**PLANNING APPROVAL &  
SUBDIVISION STAFF REPORT****Date: January 2, 2014****NAME**

Knollwood Subdivision

**LOCATION**6311 Cottage Hill Road  
(South side of Cottage Hill Road, 320'± West of Lloyds Lane)**CITY COUNCIL  
DISTRICT**

Planning Approval to allow a 150' cell tower in a B-2, Neighborhood Business District, and Subdivision approval to create two legal lots of record from an existing lot of record.

# DETAIL SITE PLAN

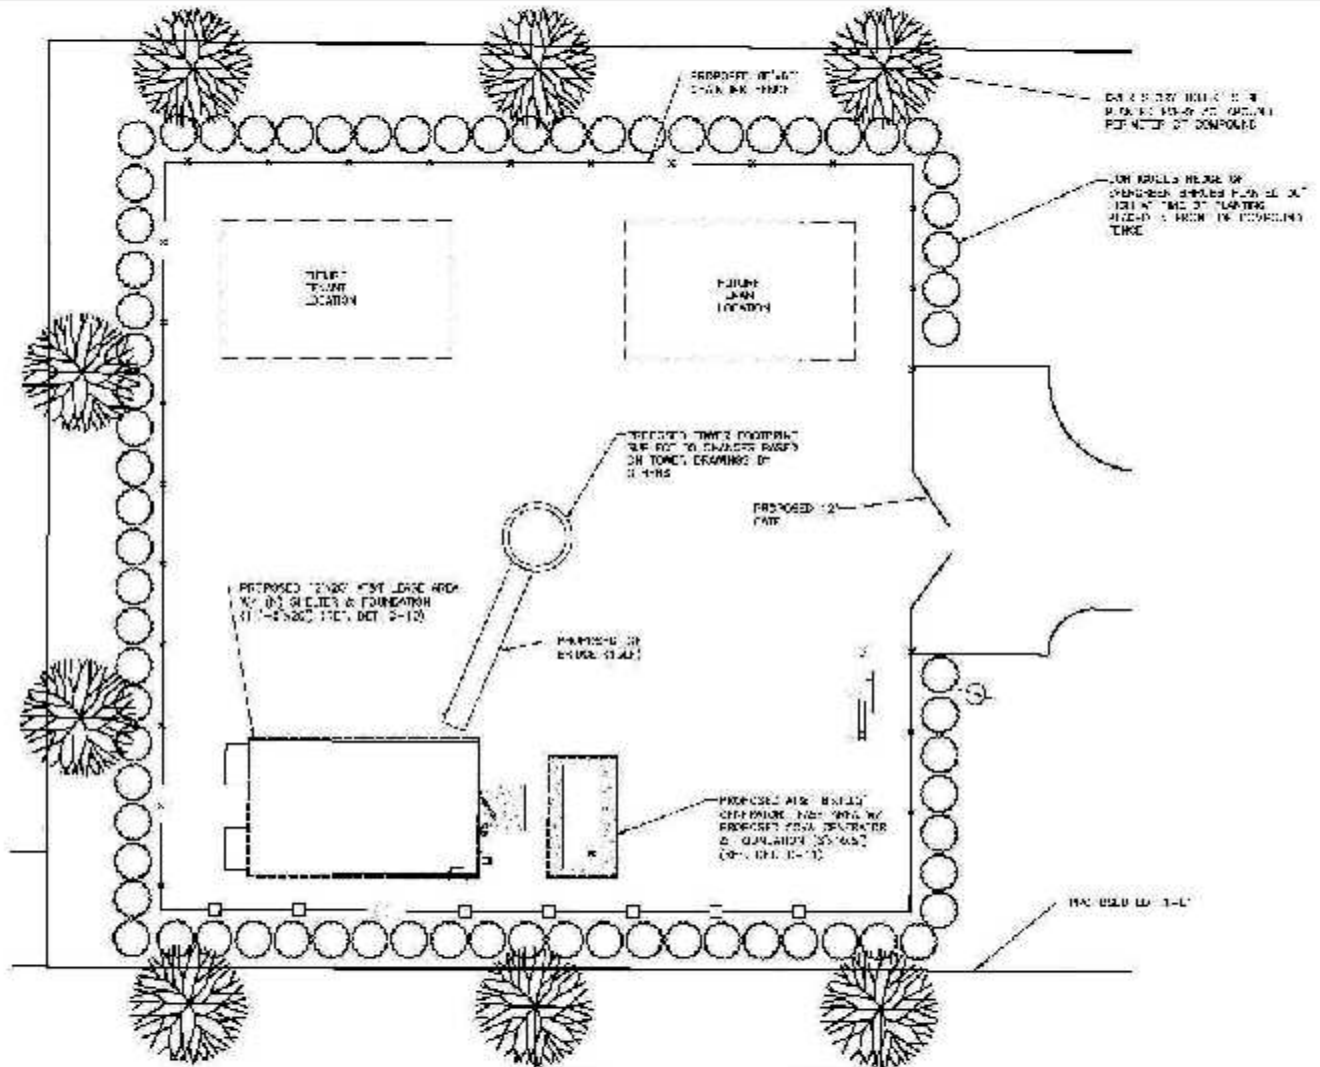
The site plan indicates the tower lease parcel to be 30' West of the 25' ingress/egress easement. Access to the parcel is across a paved 30' ingress/egress easement between the parcel and the 25' easement. A compliant vehicle parking space and turn-around are indicated on this access parcel. A chain link fence topped by barbed wire around the equipment compound is indicated. It should be noted that barbed wire fencing is not allowed in a B-2 District. Unless the applicant can provide documentation that the barbed wire fencing is required by Federal Communications

Commission (FCC) regulations, the barbed wire should either be eliminated from the site plan, or a variance to allow such should be obtained. Also, only a contiguous hedge of evergreen shrubs is indicated around the inside of the compound. If the Tree Planting Variance should not be granted by the Board of Zoning Adjustment, the site plan should be revised to indicate the required tree plantings. And due to the site's proximity to residential use, a 6'-high wooden privacy fence along the South side of the compound should be required.

*The lease area lot configuration has been revised to correspond with that of the Subdivision and the barbed wire atop the compound chain link fencing has been removed. The site plan has also been revised to provide a 6' high wooden privacy fence along the South side of the tower and equipment compound. However, since the lease area is actually the entire lot, the site plan should be revised to indicate this fence along the entire South side of the lease area lot.*

*One item not completely addressed is tree plantings. The site plan does not indicate a sufficient number of tree plantings and some tree plantings are indicated on the lease area lot and some are indicated off that lot on the adjacent new lot to the South. All required tree plantings must be on the lease area lot, and Urban Forestry has determined that sufficient area exists on that lot to provide compliant tree plantings. Therefore, the site plan should be revised to provide compliant tree plantings, all on the lease area lot, to be coordinated with Urban Forestry. Any required tree removal permits should also be obtained from Urban Forestry prior to any land disturbance activities.*

- 2) revision of the site plan to indicate compliant tree plantings, all on the lease area lot, to be coordinated with Urban Forestry;*
- 3) revision of the site plan to provide a 6' high wooden privacy fence along the entire South line of the lease area lot;*

# DETAIL SITE PLAN

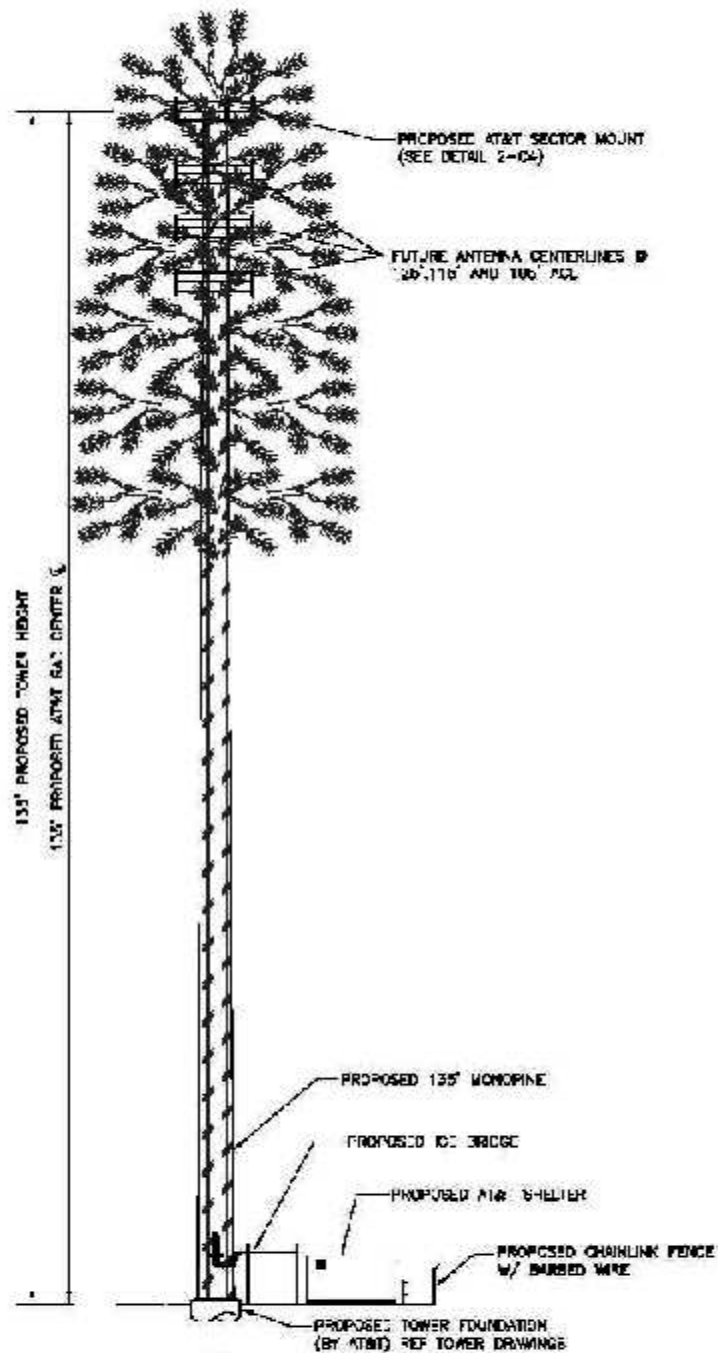
It should be noted that the tower elevation drawing indicates the top antenna segments to extend above the proposed 150' elevation. The over-all height of the communications equipment/structure (antennae/tower) should not extend above the proposed 150'. If design constraints do not allow the lowering of the antennae, this application should be revised to allow the required height above 150'.

*Concerning the Planning Approval application, the applicant has now reduced the tower height from 150' to 135' and proposes a tree-simulation camouflage design in keeping with Section 64-4.J.16. of the Zoning Ordinance. Although the height has been lowered, the top antenna array extends slightly above the 135' tower height. Therefore, that antenna array should be lowered*

*so that no portion exceeds the 135' tower height. Since the tower is now proposed to be of a camouflaged design, the top of the camouflage should not exceed 150' in height.*

- 1) revision of the tower elevation drawing to indicate the maximum height of the tower/antennae to not exceed 135' over-all height, and the maximum height of the camouflage tree pattern not to exceed 150';*
